# Consumer Advocate

CA-SIR-1

**Ref: System Protection - HECO March 3, 2004 Pukele Substation Outage, pages 19 - 22**

Figure 1:  
Current Differential Scheme

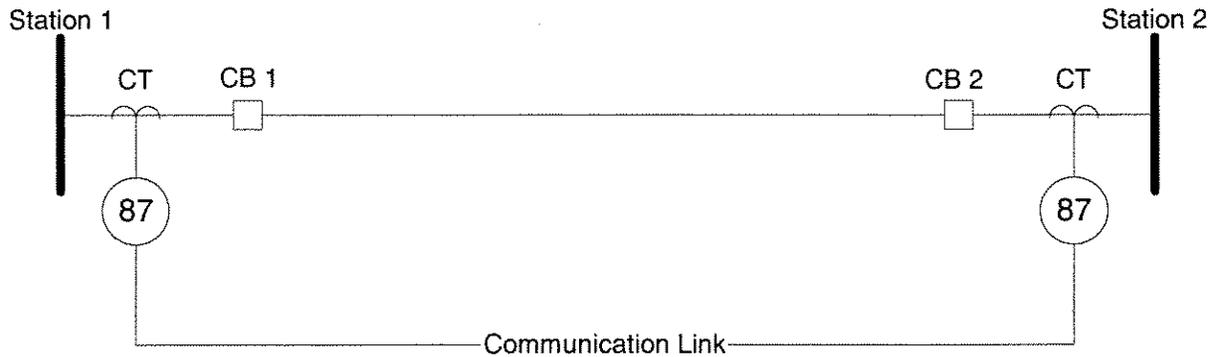
- a. Does HECO utilize a Permissive Overreaching Transfer Trip (POTT) scheme on all 138 kV transmission lines on the system?
- b. If no, please provide diagrams and descriptions of other protective schemes utilized on the 138 kV transmission system.
- c. Does HECO utilize backup protection relays on the 138 kV lines?
  1. If so, identify the type (distance, directional overcurrent, etc.) of relays used and explain why these relays are used.
  2. If no, explain why not.
- d. Please provide a protection one-line diagram for each type of protection scheme utilized on the 138 kV system.
- e. Please provide a brief synopsis of each type of protection scheme utilized.

- a. No. The POTT scheme is applied to most 138 kV transmission lines, however, short 138 kV transmission lines use a current differential scheme.
- b. A current differential scheme provides primary protection for short 138 kV transmission lines. Please see Figure 1, which is attached as page 2.
- c. Yes, backup protection is used on all 138 kV transmission lines. Backup protection typically consists of a directional time over-current scheme for ground protection, and a step-distance scheme for phase protection.
  1. See the response to subpart c.
  2. Not applicable.
- d. Please see Figures 1-3, attached as pages 2-4.
- e. Please see Figures 1-3, attached as pages 2-4.

The current differential relays (Device 87) detect faults on the protected transmission line by measuring the current magnitude and phase angle at each end of the transmission line, and sending this information to the relay at the other end of the line over the communication link. Tripping is initiated when the calculated difference in current magnitude and phase angle between the two ends exceeds a predetermined value.

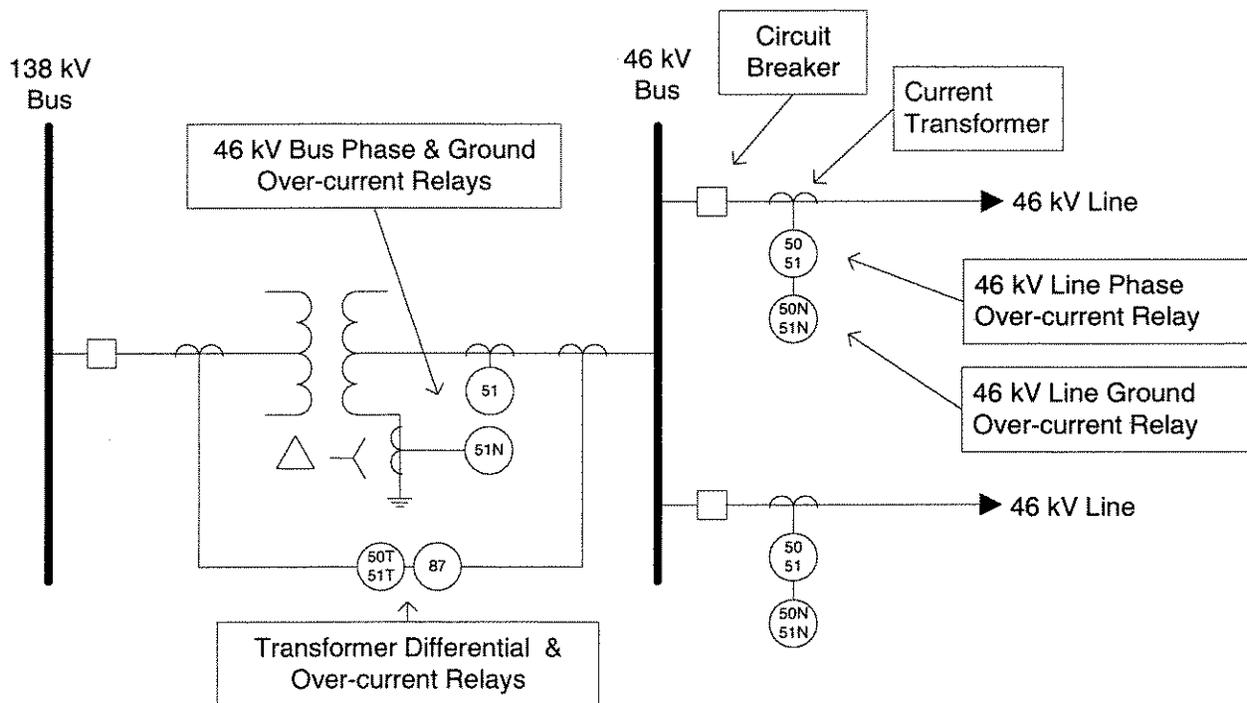
Please provide information regarding protection of typical 46 kV substations. This request is not meant to require HECO to complete an exhaustive effort to produce protection diagrams for each 46 kV substation. Rather, a typical one-line diagram with protection elements identified and a brief synopsis for typical substation types will be adequate.

Typical 46 kV protection includes protective relays for the transformer, bus, and 46 kV radial lines, as shown in the figure below:

All 46 kV radial lines are protected by phase over-current relays (Device 50/51) and ground over-current relays (Device 50N/51N). Primary phase fault protection for the 46 kV bus sections is provided by the transformer secondary over-current relay (Device 51). An over-current relay

connected to the transformer neutral (Device 51N) provides primary ground fault protection for the bus and the transformer secondary winding. Transformer primary protection is provided by a current differential relay (Device 87). Backup transformer protection is provided by an over-current relay (Device 50T/51T).
